NEW BRIDGEWATER BRIDGE MAJOR PROJECT

Representation by Geoff Lucas to the Tasmanian Planning Commission

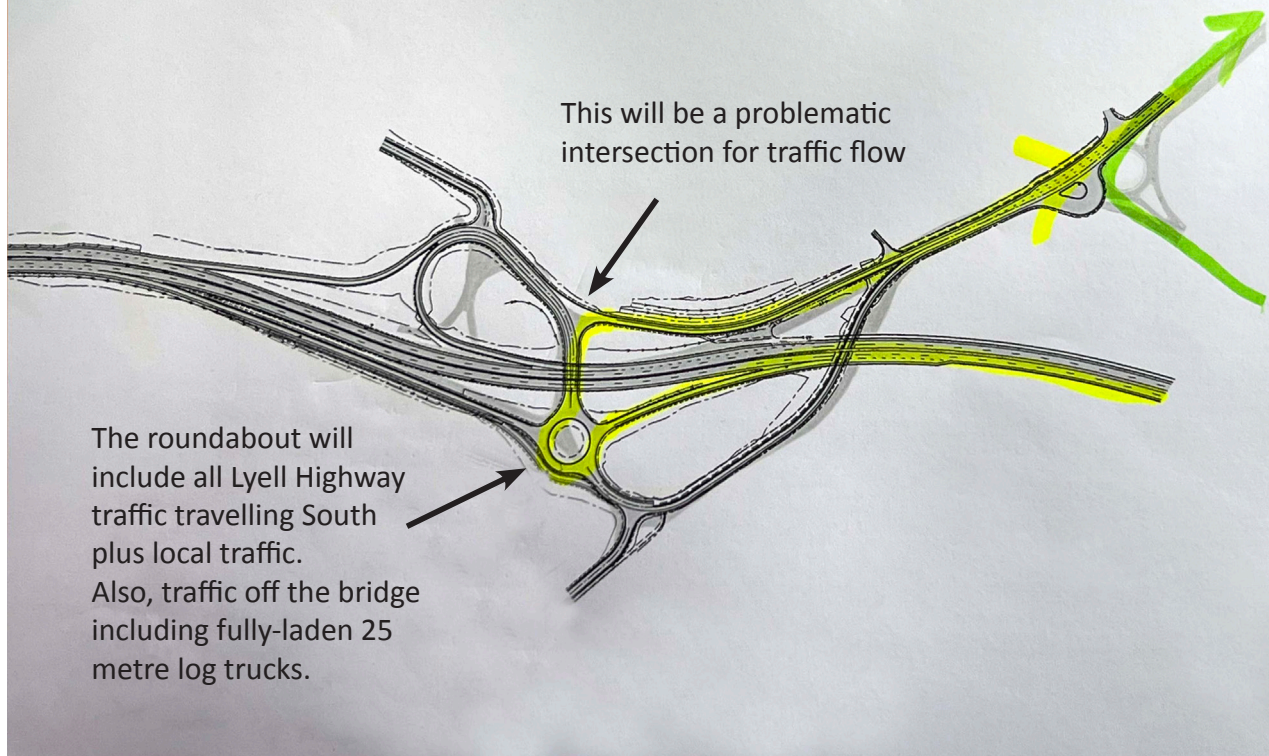
My representation will focus on the Southern (Blacksnake Lane) interchange. My comments:

- "*There is a relatively low incidence of historic injury crashes within the study area*" - quoting the Midson report, page 48. The chart on page 49 shows a five year average of 14 accidents in the study area. 5 of these are in the bridge corridor (most probably the roundabouts at either end) and the other significant location is the Blacksnake Lane interchange (3 per year). This doesn't sound many, but with relatively much fewer traffic volumes, it's significant.

- In the chart, the projections show no change in crashes. This will not be correct. The Blacksnake Lane interchange will have all of the Lyell Highway Traffic added to it. Approximately 12,000 extra vehicles per day will be navigating this interchange that includes:

- A 4 leg roundabout where Lyell Highway through traffic will have to give way to local traffic, and also traffic coming off the bridge that wants to go to New Norfolk

- All of the fully-laden 25 metre log trucks going to Boyer - they can't use Boyer Road as they exceed the load rating for that road. These trucks will come down off the bridge into the roundabout, navigate safely around it, climb up an incline under the highway from (almost) a standing start, stop and give way when they intersect with northbound Lyell Highway traffic, then restart when they find a gap. Aside from the trucks themselves, any traffic behind them will be held up. When you consider that at present they come across the causeway to the roundabout and turn right on to the Lyell Highway and off to New Norfolk, this is a good example of how this bridge design has decimated the Lyell Highway/Bridgewater Bridge intersection for users of the Lyell Highway.

- The project managers have promoted the Lyell Highway through-traffic as being unimpeded. This could not be further from the truth. An example is Southbound traffic will reach the roundabout and have to give way. Then they are facing a steep incline to get on to the Brooker. For modern cars this might not be an issue, but every truck and bus traveling the Lyell Highway will not be as lucky - having to climb a steep on-ramp from a standing start - and every car behind them will feel the same pain.

The following page illustrates what is proposed for Lyell Highway on and off the bridge.

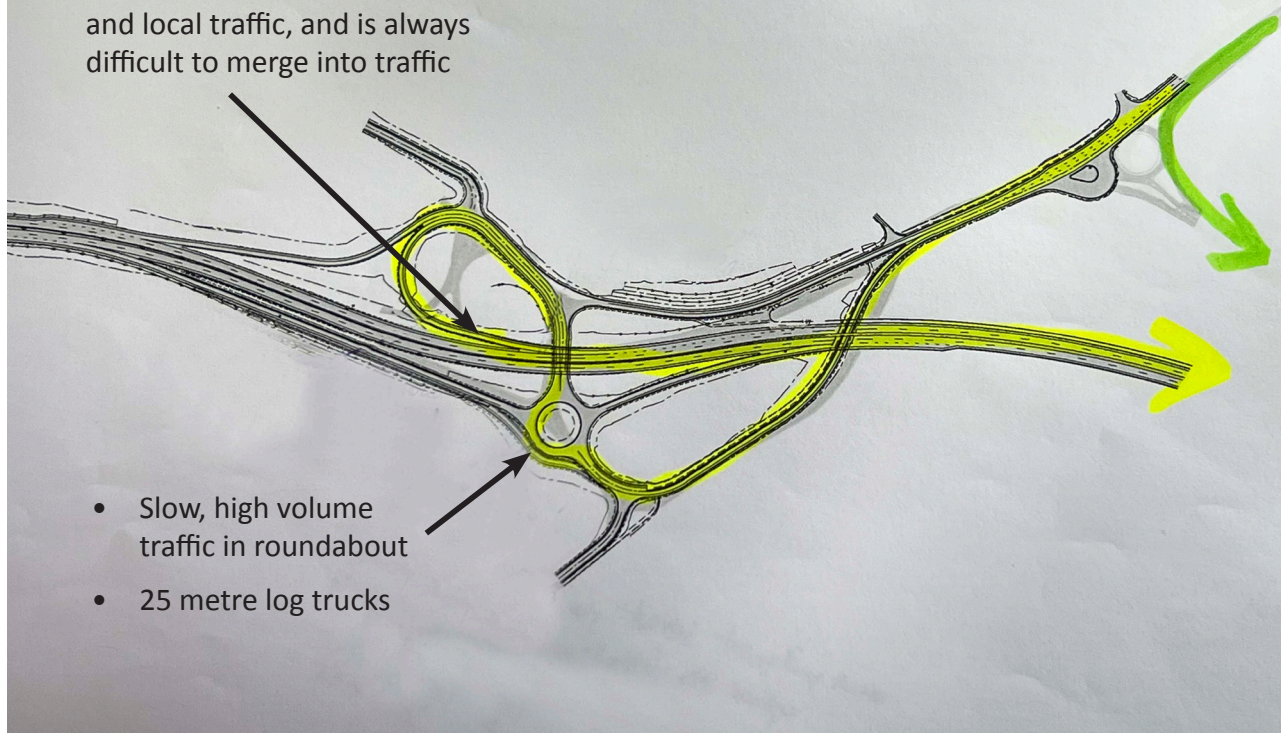
- From a safety point of view, replacing a single roundabout to interchange traffic on the Western side of the bridge with grade separation at Blacksnake Lane has added several new potential black spots and due to increased traffic volumes in local roads, has increased safety concerns for present intersections and also built in slowing of the traffic at multiple locations and for multiple reasons (Ref my notes earlier on trucks etc).

- The Austroads Guide to Road Design Part 4B clearly articulates that roundabouts slow traffic down. Also that legs should intersect at approximately 90 degrees and that the roundabout should be clearly visible from the approach sight distance at the road operating speed. Neither of these criteria are met with the proposed design.
